# **Kintyre Uranium Project**

## **Environmental Review Management Programme**

### **ASSESSMENT NO. 1845**

#### **SUMMARY OF PUBLIC SUBMISSIONS**

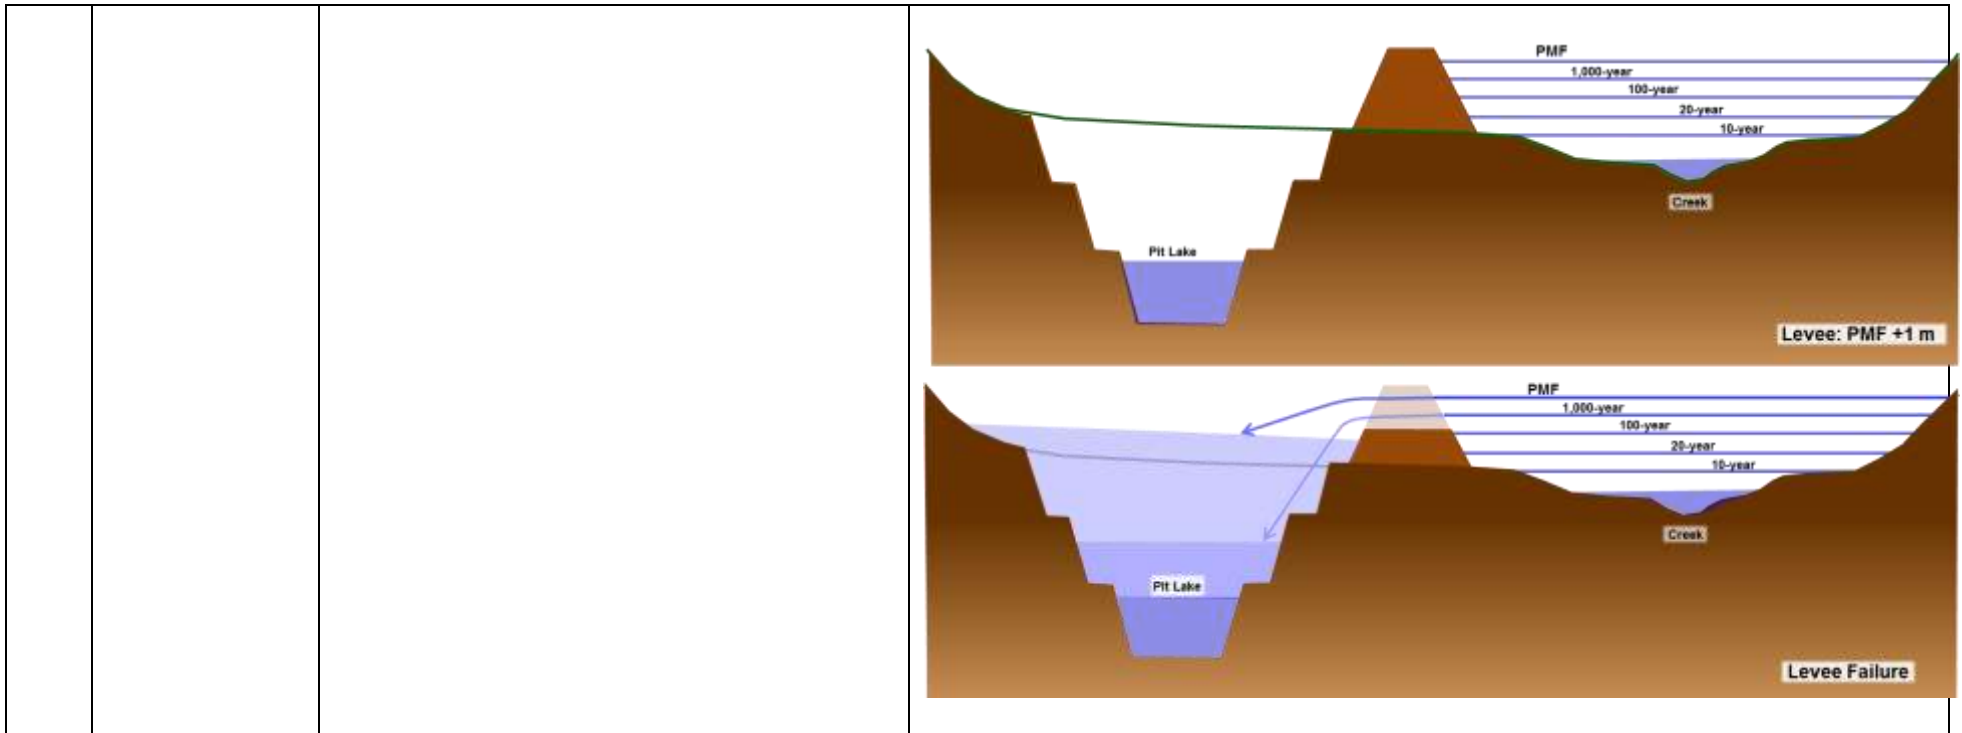
134	Members of the Public	The submitter contends that the surface water flow needs further review regarding the potential for water to flow to Lake Dora.	There is evidence that under extreme flood events, Yandagooge Creek discharge will flow across country to enter Rudall River before discharging into Lake Dora.
135	Members of the public	The submitters comment that bunds should be designed to cope with severe flooding events.	<p>The pit levee (bund wall) will be built to contain the probable maximum flood event. This will be achieved by designing the wall to PMF specifications plus an additional 1m in height.</p> <p>This is illustrated in the Figure below (titled Levee: PMF + 1m).</p> <p>Failure of the Levee would not cause flood events up to the 1,000-year ARI event are not likely to overtop the pit, even if the pit were to capture the entire creek. Under these scenarios, the pit would remain a terminal sink. This is illustrated in the Figure below (titled Levee Failure).</p> <p>The analyses indicate that, if routed into the pit, floodwater associated with the PMF event would overtop the pit and return to Yandagooge Creek.</p> <p>The technical memo discussing surface water management in more detail is attached as Attachment 8.</p>
